# SITE PLAN SET FOR PROPOSED SINGLE FAMILY HOME

**PLAT MAP D, LOT 205-5  
ZONING DISTRICT R10  
RESIDENTIAL-HIGH DENSITY DISTRICT**

**CONGDON STREET  
NARRAGANSETT, RHODE ISLAND**

DEPARTMENT OF ENVIRONMENTAL MANAGEMENT  
OFFICE OF WATER RESOURCES  
FRESHWATER WETLANDS PROGRAM  
APPROVED WITH CONDITIONS  
AS SPECIFIED IN THE LETTER OF APPROVAL  
DATED: FEB 13 2017 FILE # 16-0067  
NO CHANGES ALLOWED WITHOUT PRIOR APPROVAL  
APPROVED PLANS MUST BE AT CONSTRUCTION SITE

**DRAWING TITLE:**  
**WETLAND HABITAT AND MITIGATION PLAN**

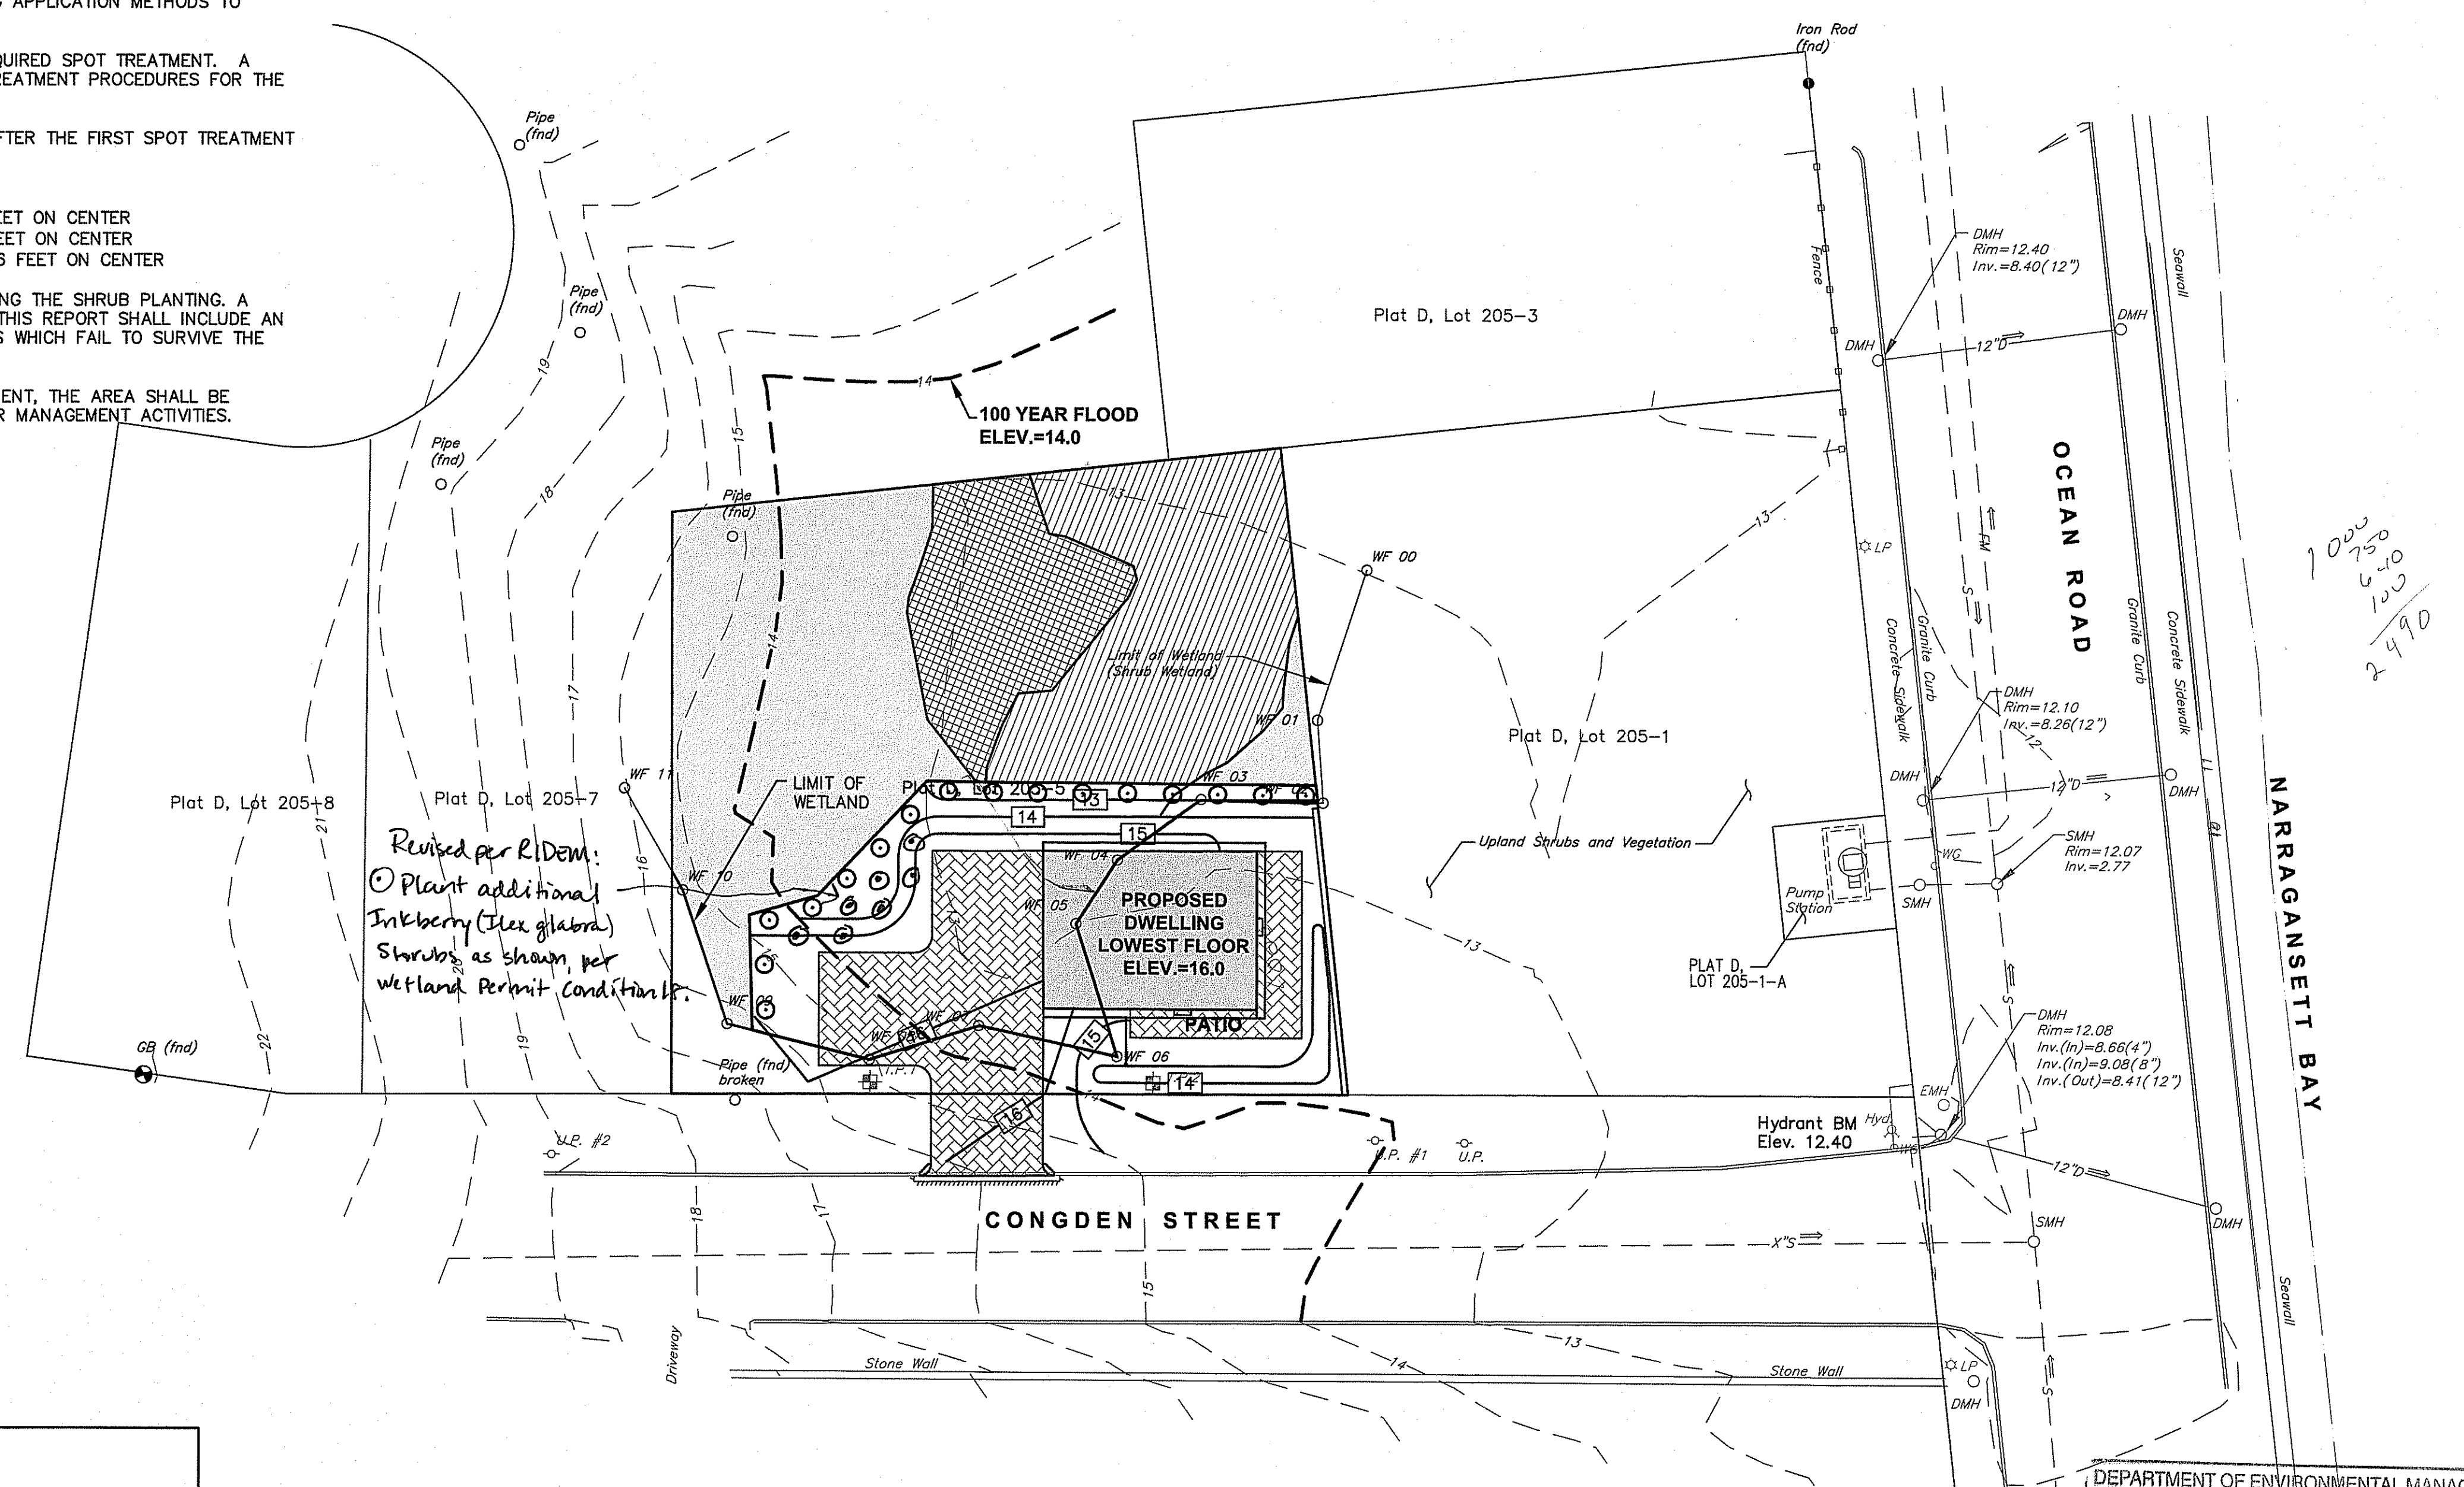
Revised per R.Dem:  
 Plant additional Inkberry (Ilex glabra) shrubs as shown per wetland permit conditions.
